HISTORIC AND DESIGN REVIEW COMMISSION

October 19, 2022

HDRC CASE NO: 2022-499
ADDRESS: 2004 MONTEREY ST
LEGAL DESCRIPTION: NCB 2353 BLK 3 LOT N 112 FT OF 10 AND 11 AND 12 R-4, HS
ZONING: 5
CITY COUNCIL DIST.: Individual Landmark
LANDMARK: Natalia Quesada
APPLICANT: Abdel Quesada,
OWNER: Abdel Quesada/ Deluyana Ventures, LLC
TYPE OF WORK: Site work, porch replacement, parking lot installation, exterior and fenestration modifications
APPLICATION RECEIVED: September 23, 2022
60-DAY REVIEW: Not applicable due to City Council Emergency Orders
CASE MANAGER: Edward Hall

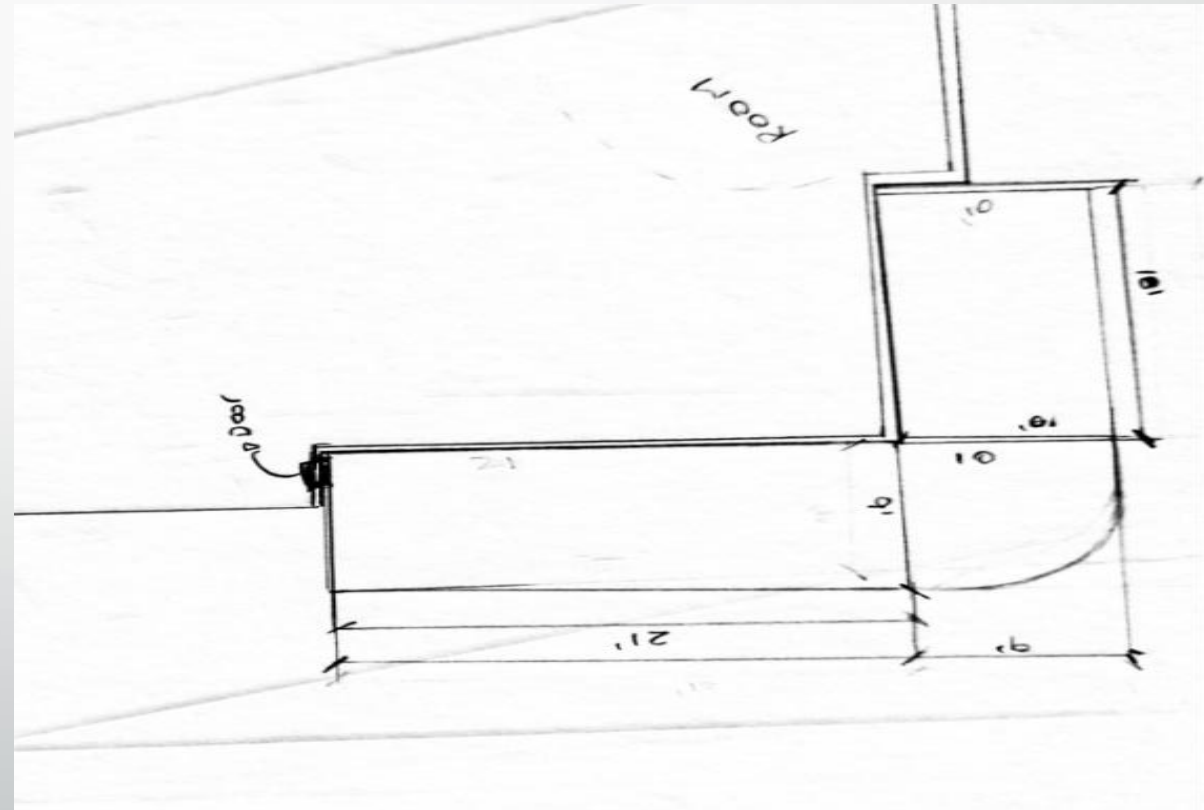
§Reconstruction of the front porch. Please provide construction documents that are to-scale, as shown in the example below. Do you plan to construct a porch roof, or only install a new wood deck? Will the existing shape be maintained?

- Do you plan to construct a porch roof, or only install a new wood deck?
No porch roof, only install a new wood deck
- Will the existing shape be maintained?
Yes, it will be the same shape

Existing building dimensions and existing doors conservation

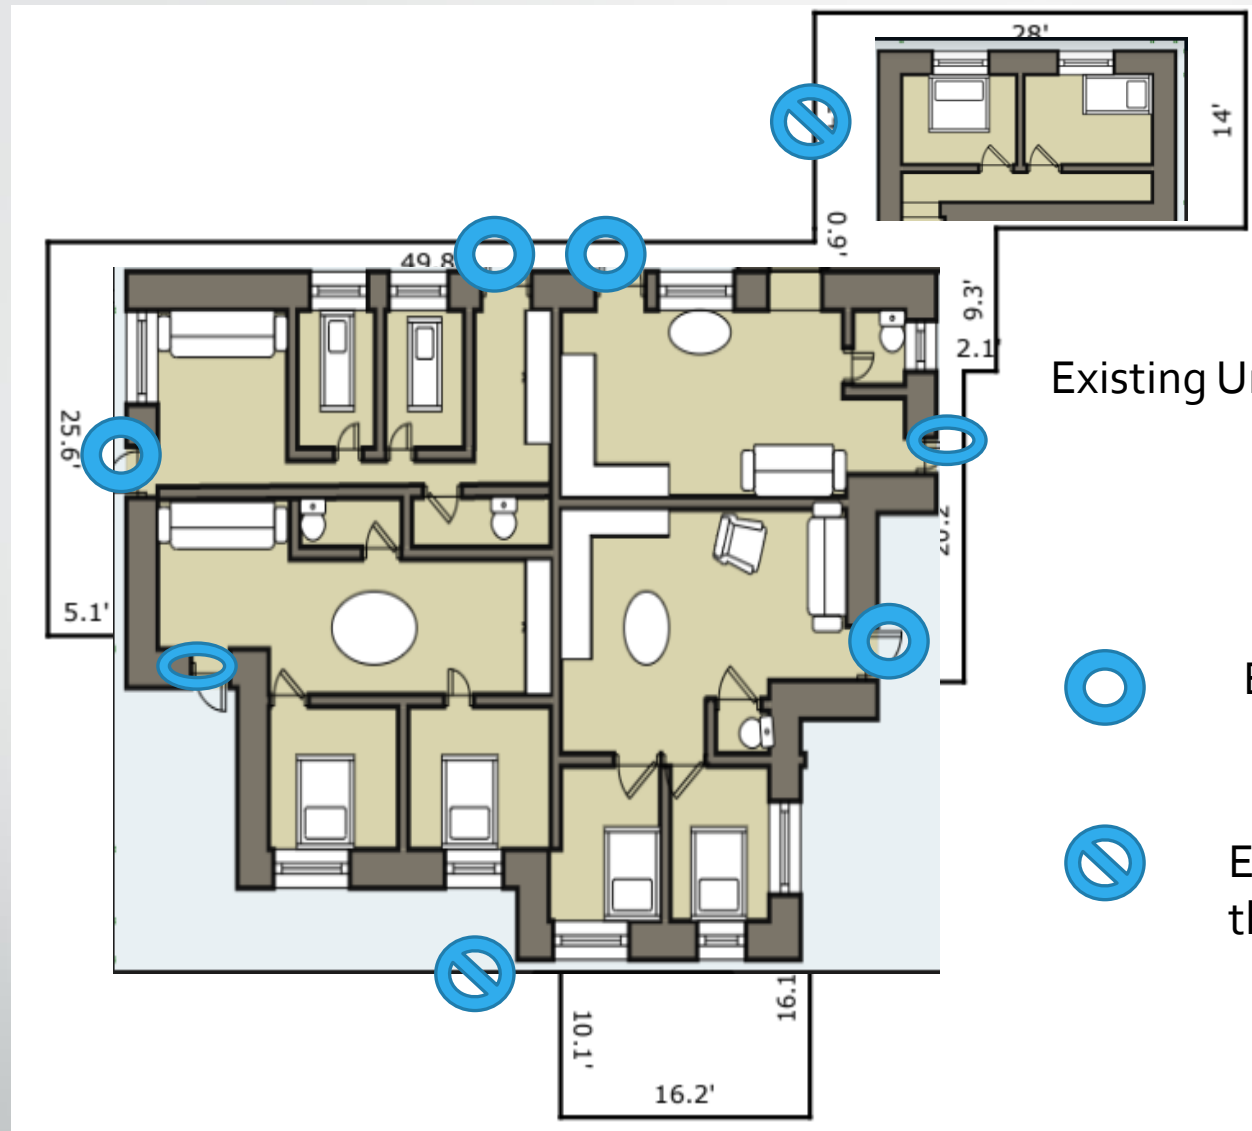
§Door/entry removal. All original door openings should remain. Please submit examples of your replacement doors, if doors are damaged beyond repair or missing.

This is the style of door we are looking at

Windows we
planning to replace

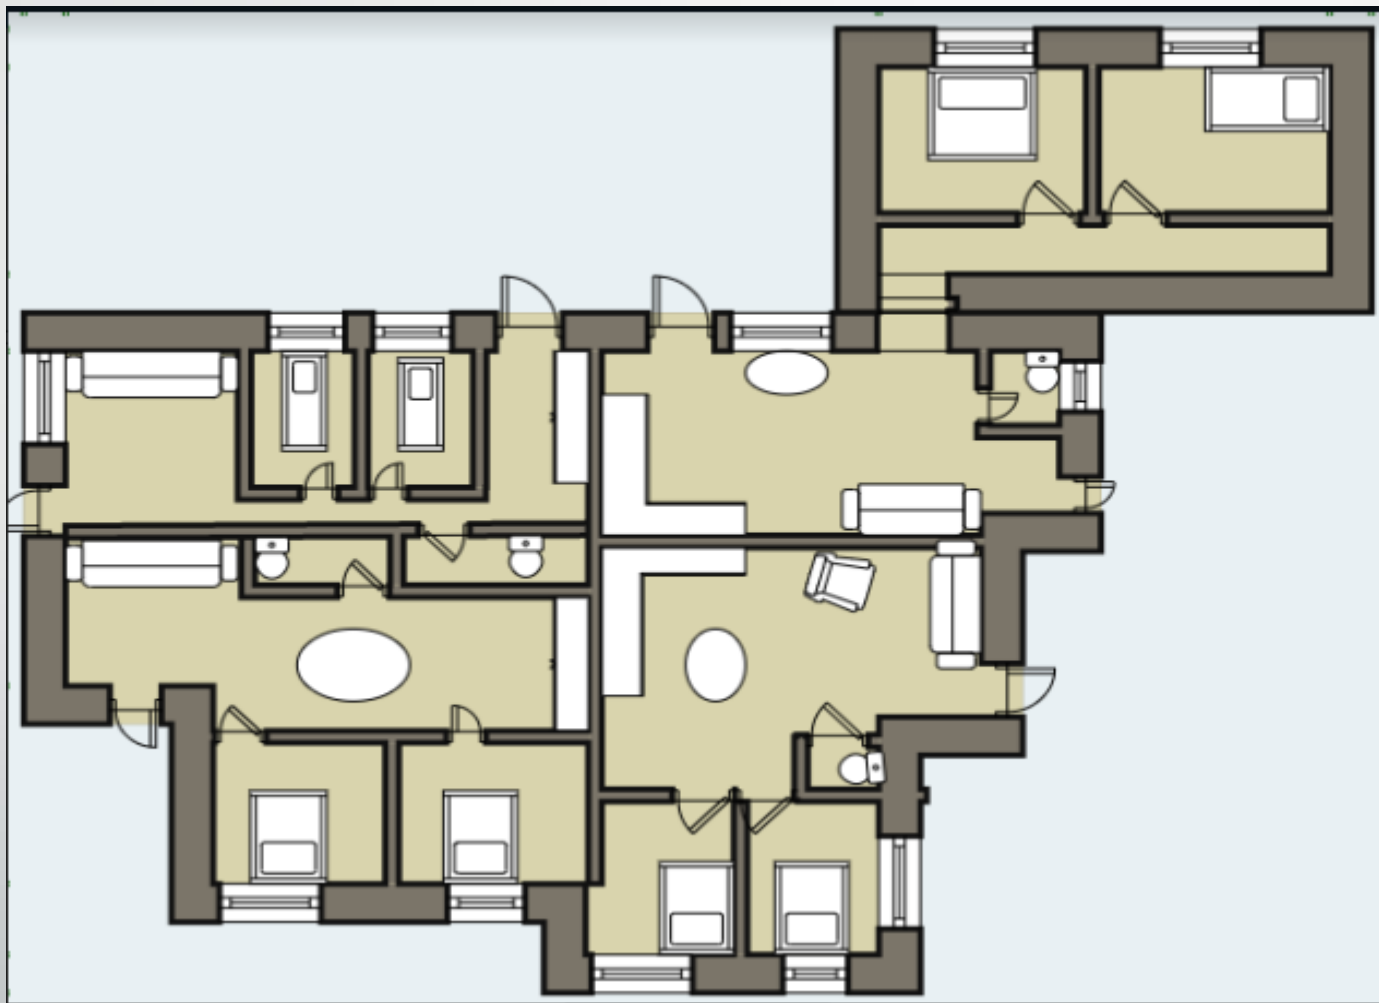
Window replacement. Please provide product specifications of the proposed replacement windows. Please also provide photos of each window you believe you may need to replace.

Exterior Color/ Finish	White	Exterior Color/Finish Family	White
Features	Venting	Frame Material	Aluminum
Frame Type	Standard Frame	Glass Type	Energy Efficient Glass, Low-EGlass
Glazing Type	Single-Pane	Grid Pattern	No Grid
Grille Type	No Grille	Hardware Color/Finish Family	White
Included	Screen	Interior Color/Finish Family	White
Lock Type	Self-Latching Lock	Number of Grids	No Grid
Number of Locks	2	Product Weight (lb.)	24 lb
Returnable	90-Day	Solar Heat Gain Coefficient	.42
U-Factor	.26	Window Type	Other
Window Use Type	New Construction, Replacement

Proposed parking spaces

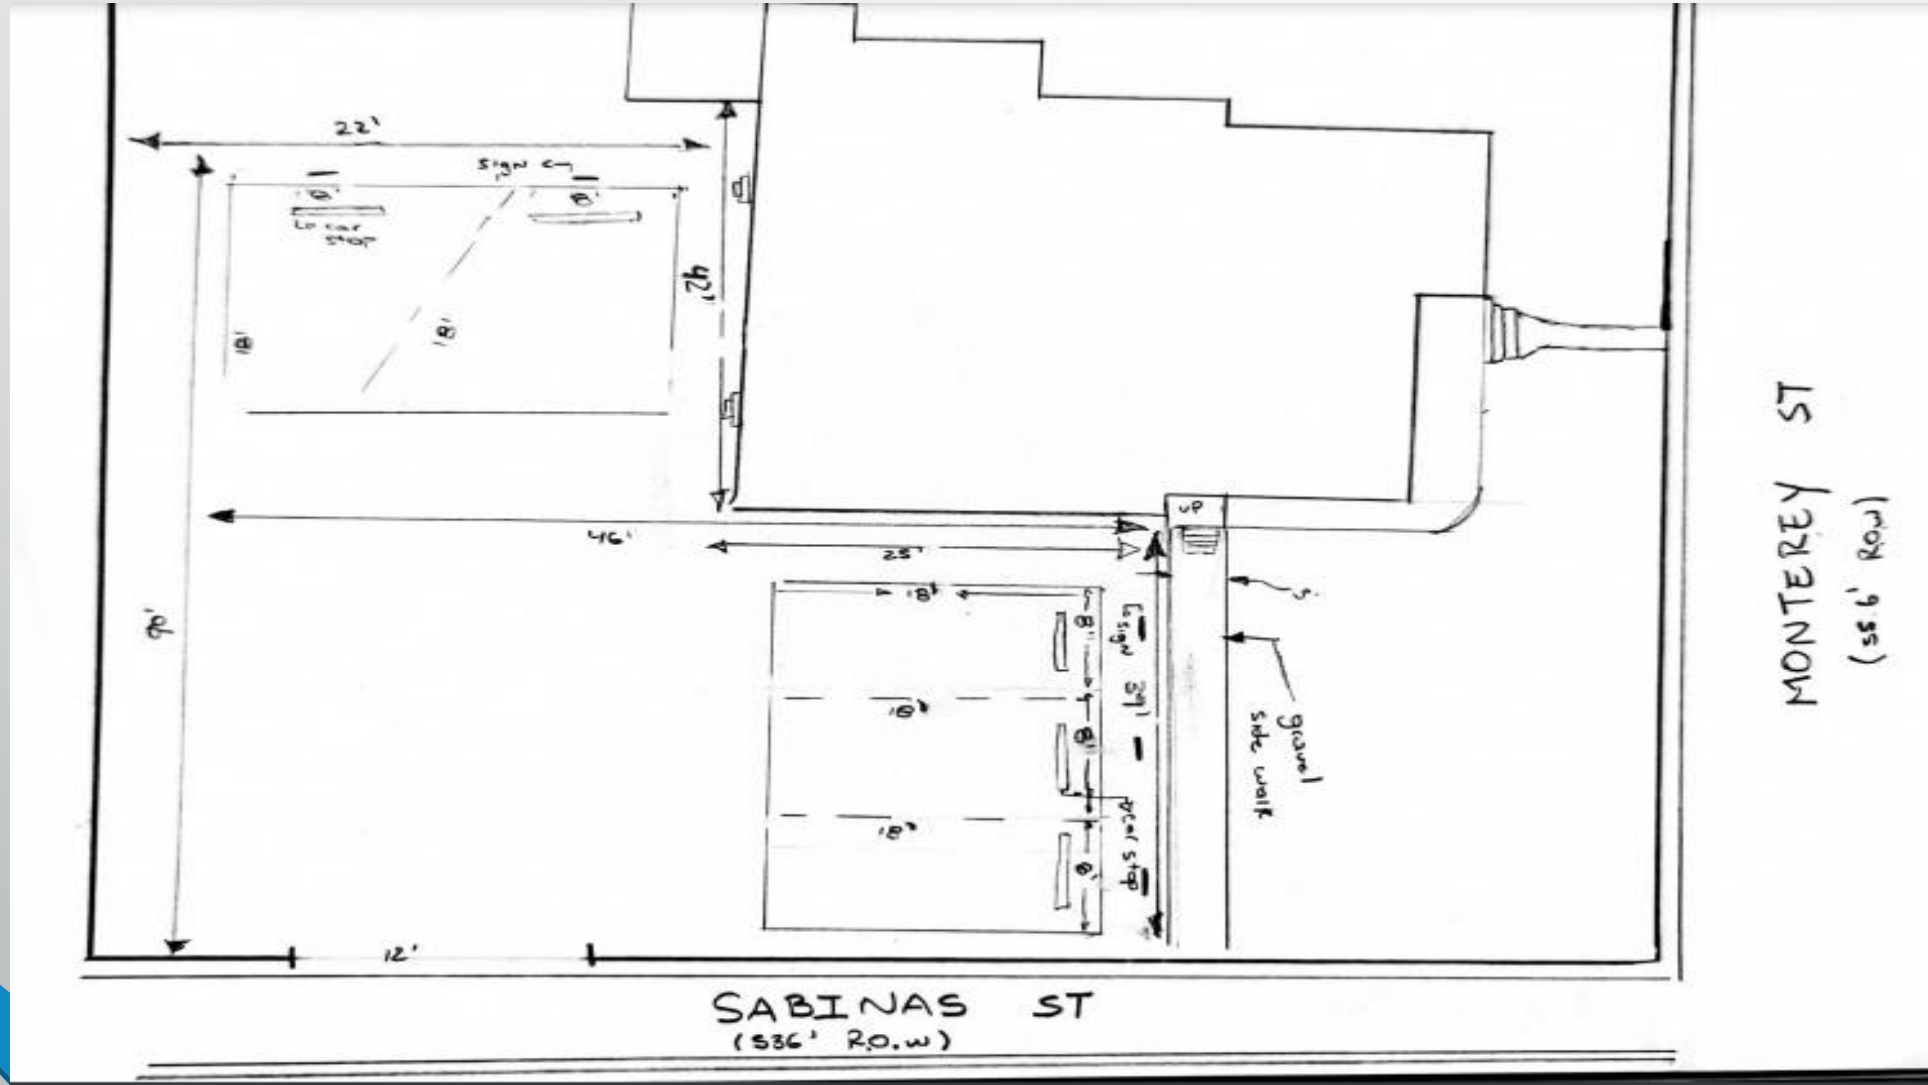
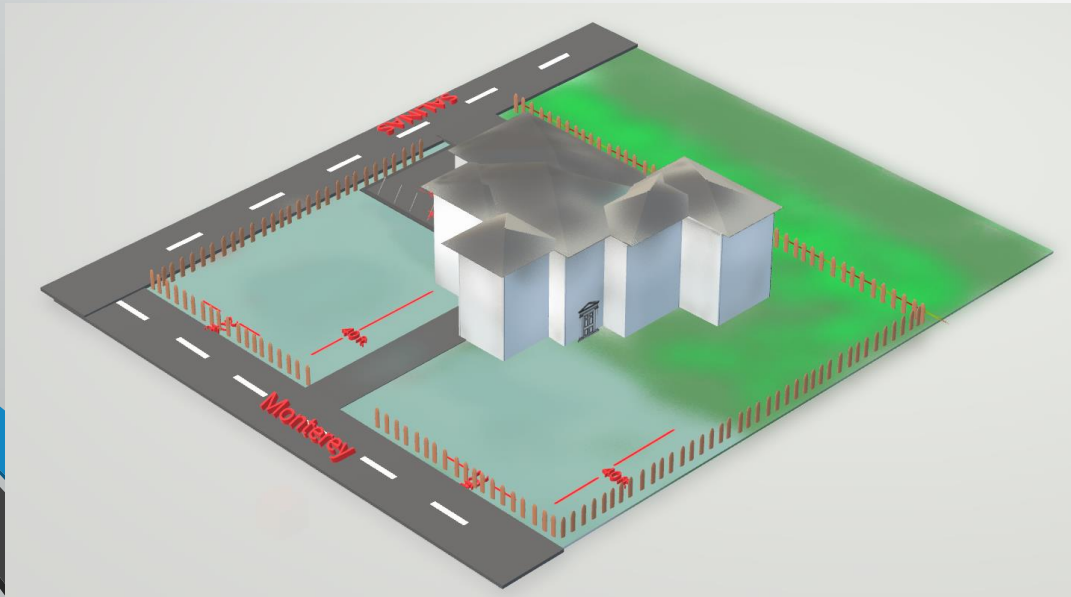
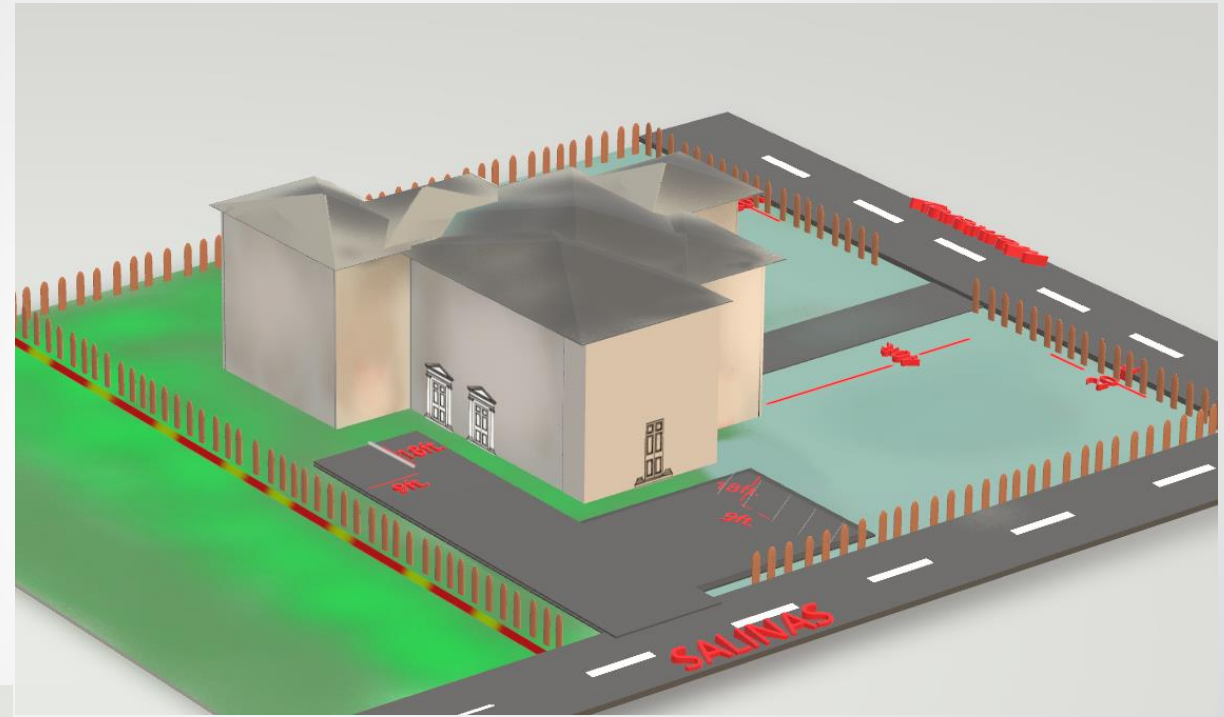
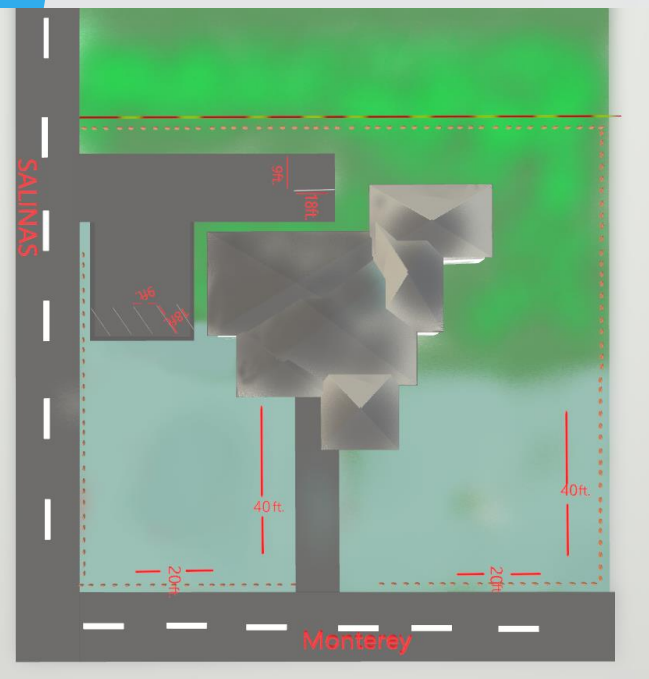
to-scale site plan noting the location of all on site-parking, as well as examples of parking materials. This should also include the driveway width, curb cuts, etc. We recommend pervious site paving, such as gravel or decomposed granite. we are going to use gravel
